RE: Frazier Farm Park CDs

Case Number: V3-CID-23-05

Response to 4th TRC Review Comments

C7.00 Louisburg Rd Widening Plan

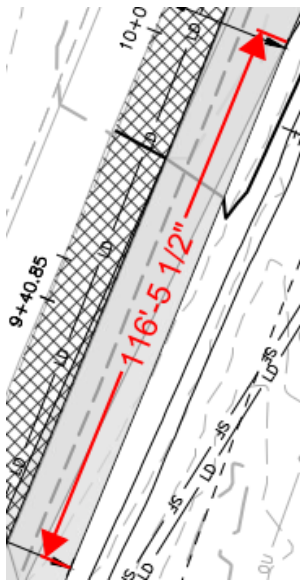
7.

Label C/A break locations on plans.

McAdams Response: C/A break locations have been added to the plan set.

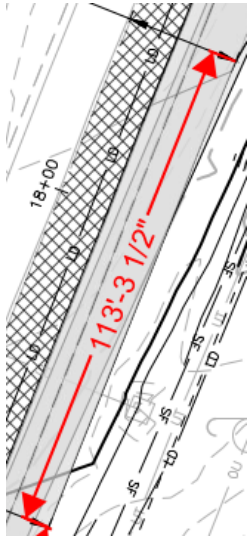
8.

At least 50' of full-width deceleration is required in addition to the turn lane storages required by the TIA.

At least 200' turn bay tapers required.

9.

McAdams Response: Taper and turn storage lengths have been updated to meet requirements for the latest submission.

McAdams Response: Taper and turn storage lengths have been updated to meet requirements for the latest submission.

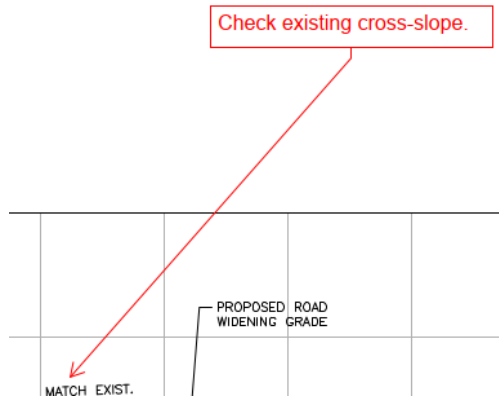
12.

Minimum paved shoulder width for this classification of road is 4'

McAdams Response: Minimum paved shoulder width has been updated to 4'.

C7.02 Louisburg Rd Widening Cross Sections

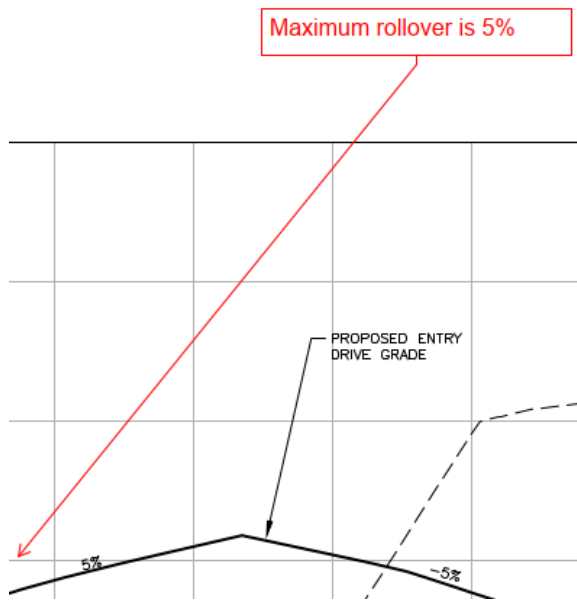
14.

15.

McAdams Response: Cross-slope and section have been updated for the latest submission.

McAdams Response: Cross section has been updated for the latest submission.

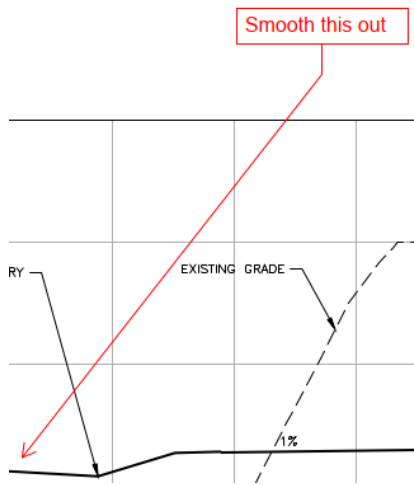
16.

McAdams Response: Cross section has been updated in the latest submission.

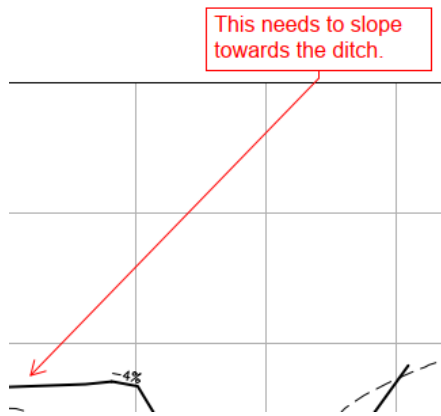
17.

McAdams Response: Cross section has been updated in the latest submission.

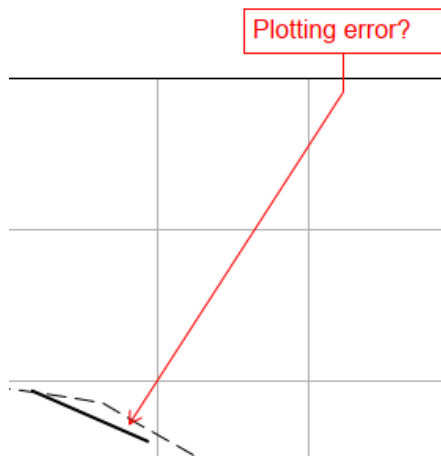
18.

McAdams Response: Cross section has been updated in the latest submission.

C7.03 Louisburg Rd Widening Cross Sections

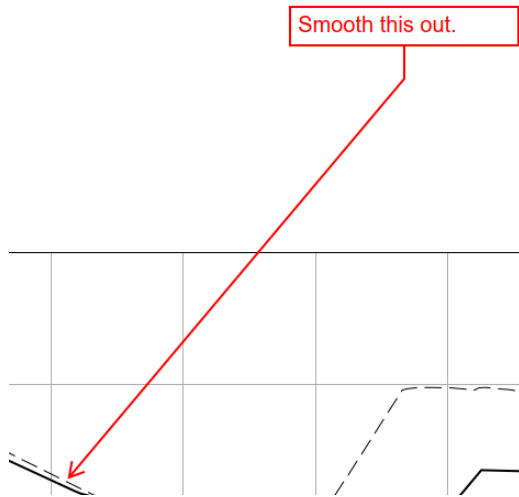
19.

Provide a cross-section that accurately shows driveway grade for northern driveway.

20.

McAdams Response: Cross section for northern driveway has been updated in the latest submission.

McAdams Response: Cross section has been updated in the latest submission.

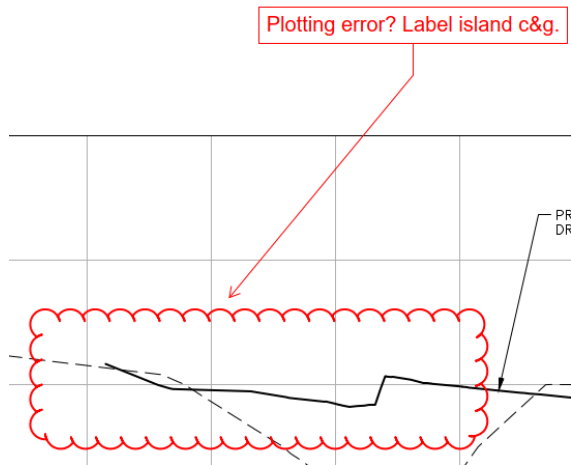
21.

McAdams Response: Cross section has been updated in the latest submission.
